**ADDENDUM 2****Addendum #** 2**Date Issued** January 27, 2026**Project Name | Job #** White Earth Withdrawal Management Facility | 20237410**Bid Date | Time** Tuesday, February 3, 2026 | 3:00 pm

THIS ADDENDUM AMENDS AND BECOMES PART OF THE CONTRACT DOCUMENTS FOR EAPC PROJECT 20245580 DATED 12/5/2025, RESPECTIVELY. EACH BIDDER SHALL ACKNOWLEDGE RECEIPT OF THIS ADDENDUM BY MARKING THE ADDENDUM NUMBER AND DATE ON THE BID FORM.

A701

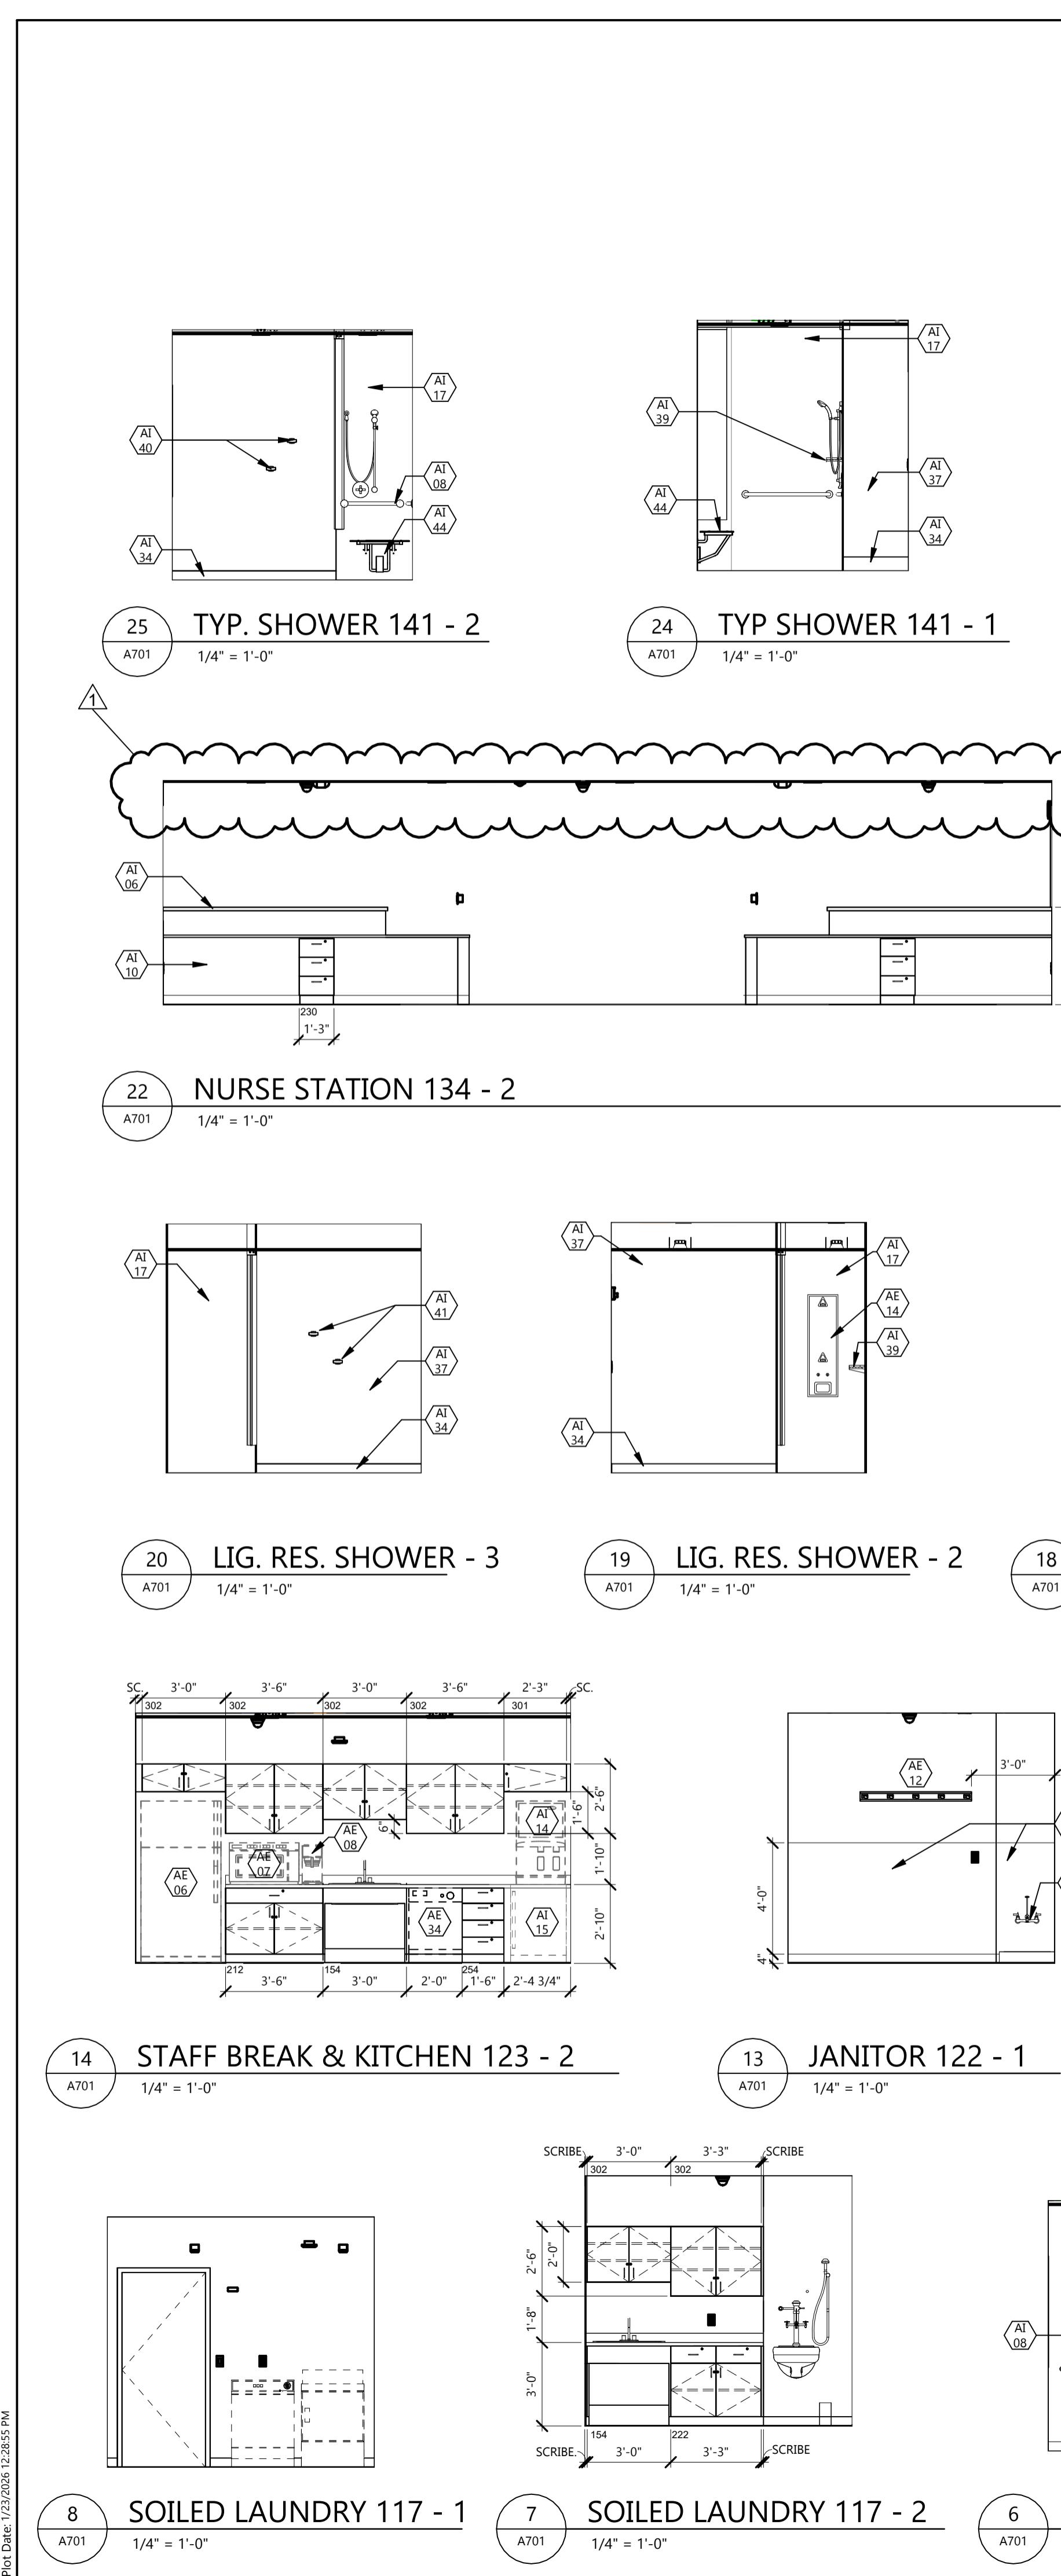
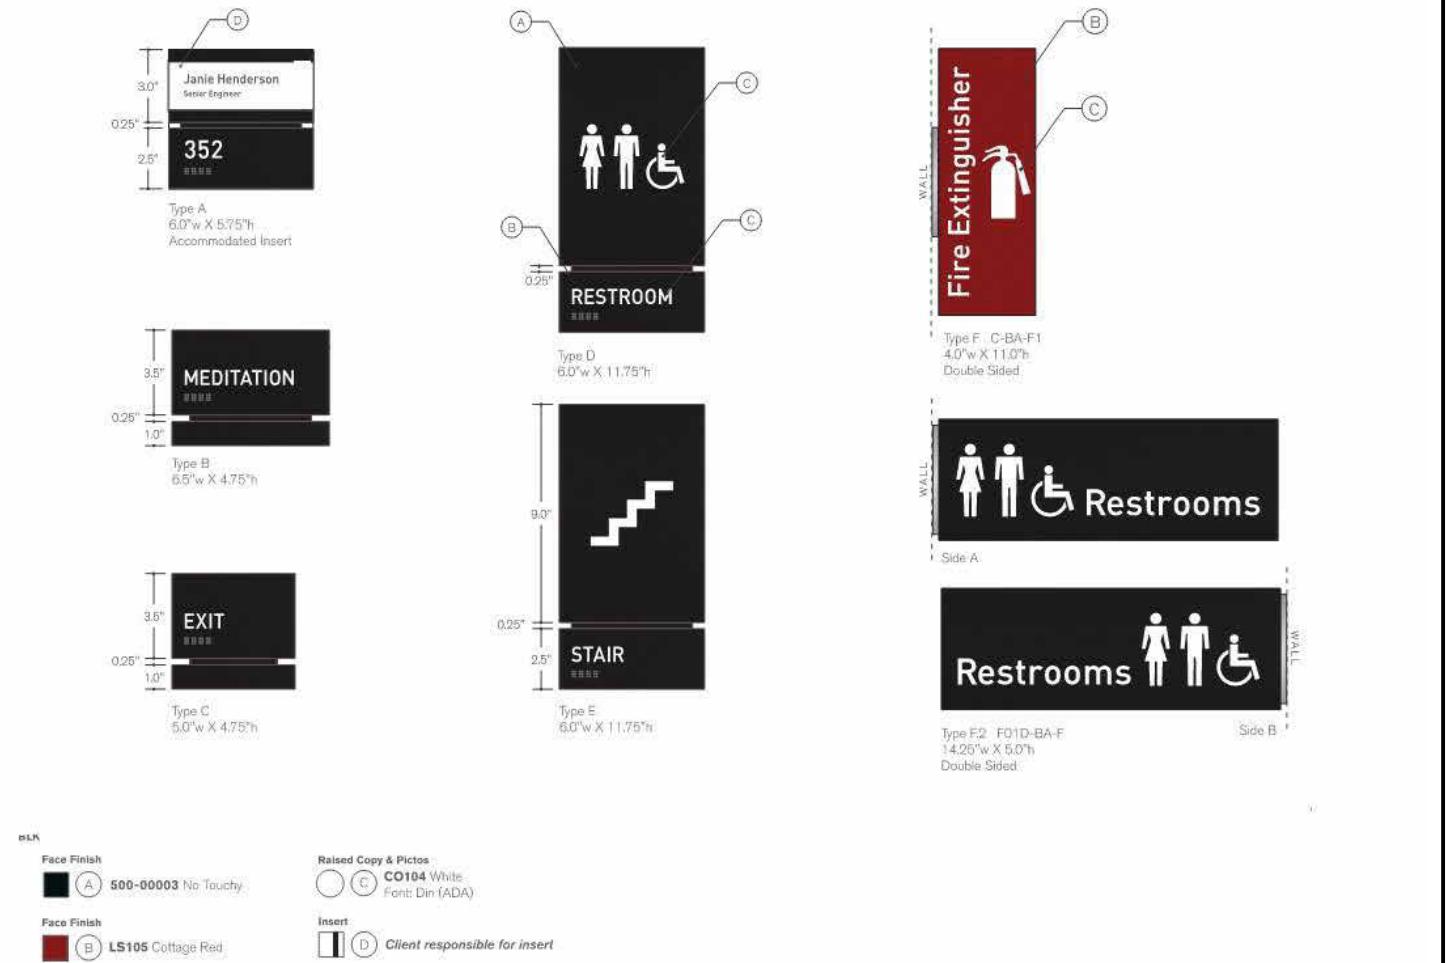
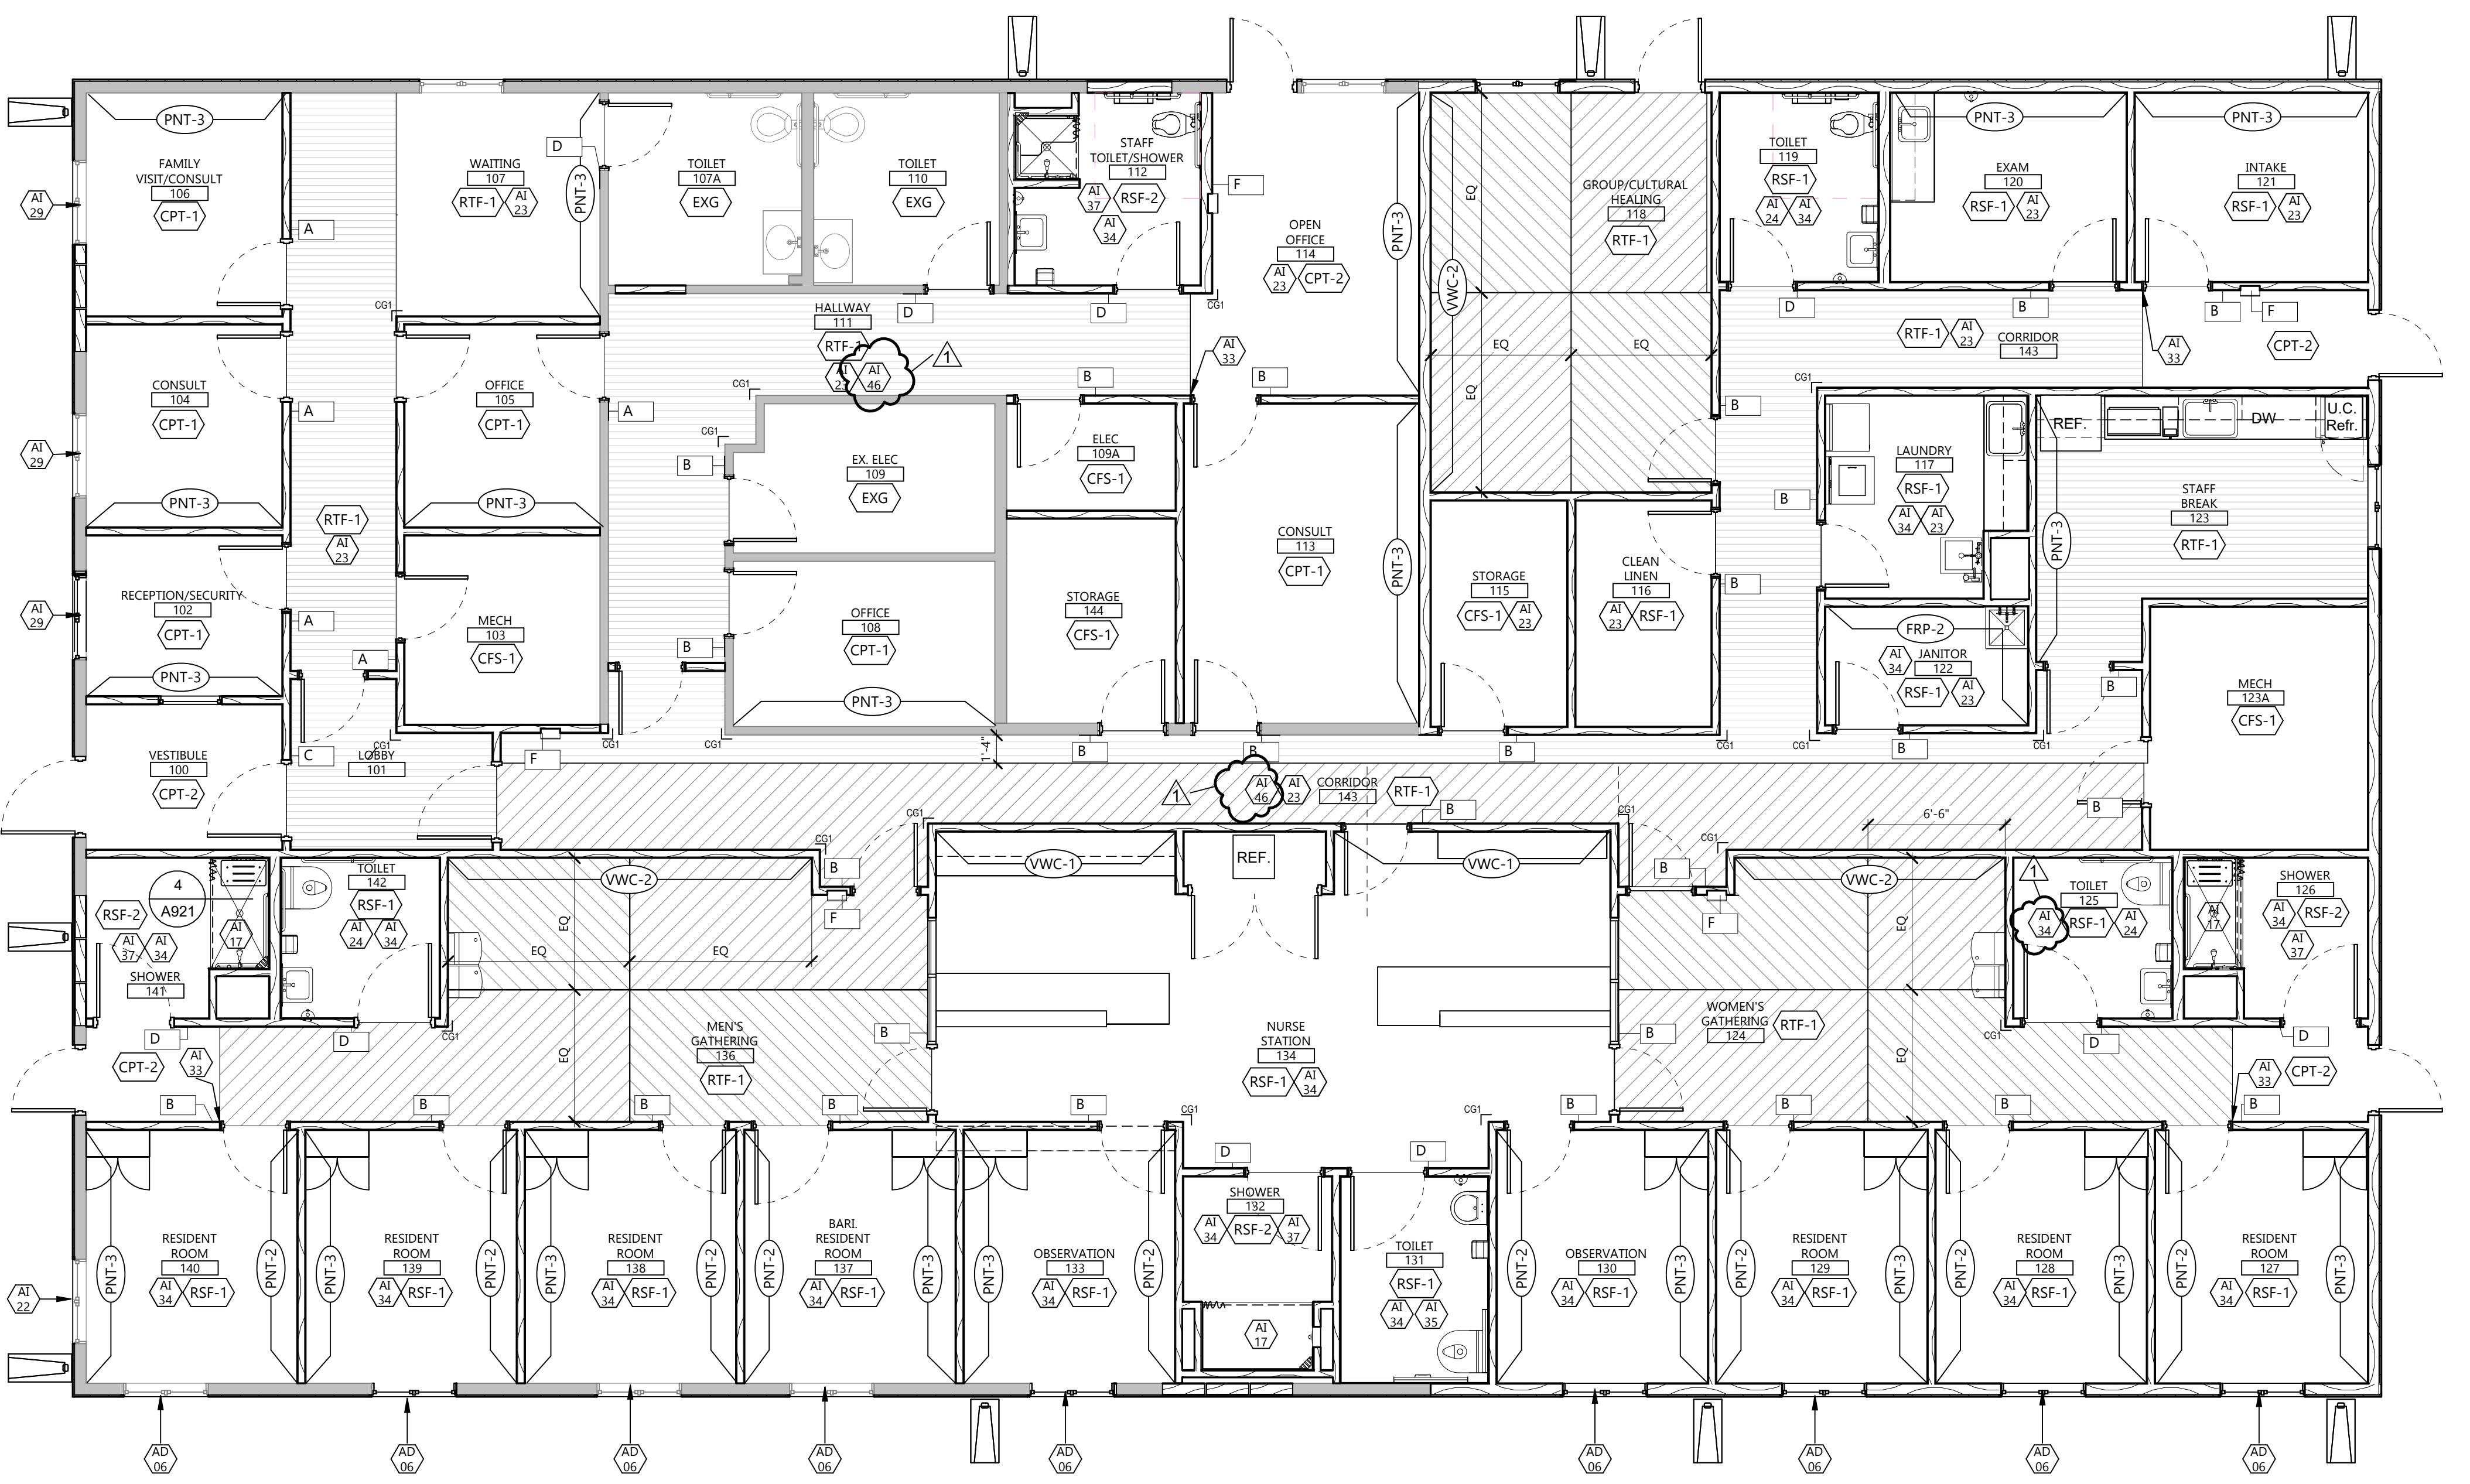
A701 Modify ceiling heights at 21/A701 22/A701 and 23/A701. Add keynote for ceramic tile at nurse desk.
